Access Compliance Report

Public Rights-of-Way

Intersection ID: 10014544	Main Street: BROOKSIDE_LN	Cross Street: N/A	Location: NE
ADA ID: BE5D54B347C5	Ramp Type: BlendTrans1	Initial Pass/Fail: Fail	Overall Compliance: No
		Severity Score: 25

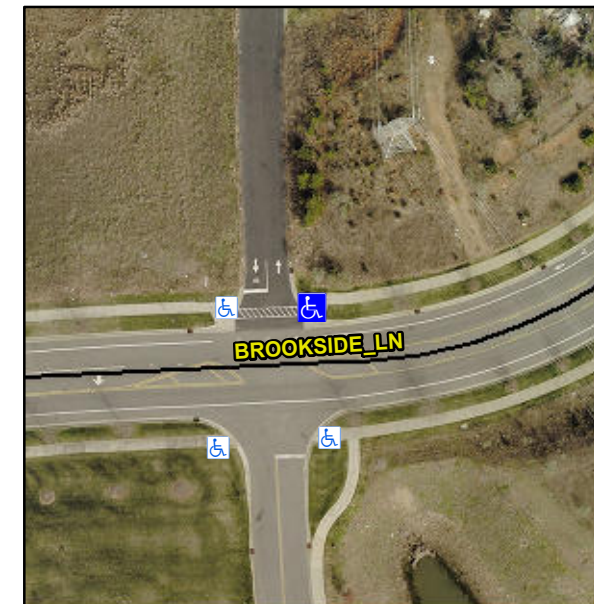
Not Found, R304.5.3

Compliance	Description	Data	Compliance	Description	Data
N/A	Ramp Length (in)	107.0	Yes	BlendTrans Slope (%)	3.5
Yes	Ramp Width (in)	48.0	No	BlendTrans XSlope (%)	13.2
N/A	Flare Type LT	N/A	N/A	Flare Type RT	N/A
N/A	Flare Slope LT (%)	N/A	N/A	Flare Slope RT (%)	N/A
N/A	Flare Traversable LT?	N/A	N/A	Flare Traversable RT?	N/A
N/A	Landing Length (in)	N/A	N/A	DWS Provided?	N/A
N/A	Landing Width (in)	N/A	N/A	DWS Contrast?	N/A
N/A	Landing Slope (%)	N/A	N/A	DWS Length (in)	N/A
N/A	Landing X Slope (%)	N/A	N/A	DWS Full Width?	N/A
N/A	Landing Curb? (Y/N)	N/A	N/A	DWS Offset (in)	N/A
N/A	Shared Landing?	N/A			
N/A	Gutter Ponding?	N/A	N/A	Gutter Slope (%)	N/A
N/A	Gutter Lip Ht (in)	N/A	N/A	Gutter X Slope (%)	N/A
N/A	Painted X Walk1?	Yes	N/A	Painted X Walk2?	No
	X Walk 1 Direction	To W		X Walk 2 Direction	To S
	X Walk 1 Width (in)	52.0		X Walk 2 Width (in)	N/A
	X Walk 1 Slope (%)	2.0		X Walk 2 Slope (%)	0.7
	X Walk 1 X Slope (%)	8.7		X Walk 2 X Slope (%)	4.3

N/A	Ramp inside XWalk1?	Yes	N/A	Ramp inside XWalk2?	N/A
	Road Slope (%)	13.2		Clear Space?	N/A
	Road X Slope (%)	2.8	N/A	Clear Space to XWalk (in)	N/A
N/A	Any Obstructions?	N/A	N/A	Storm Grate/Utility Hazard?	N/A
	Obstruction Type			Storm Grate/Utility Type	
		N/A			N/A
		Yes		Surface Condition? (G/P)	Good
		No		Curb Slope (%)	6.9

Remove & Replace Curb Ramp With Two New Directional Ramps or Equivalent.
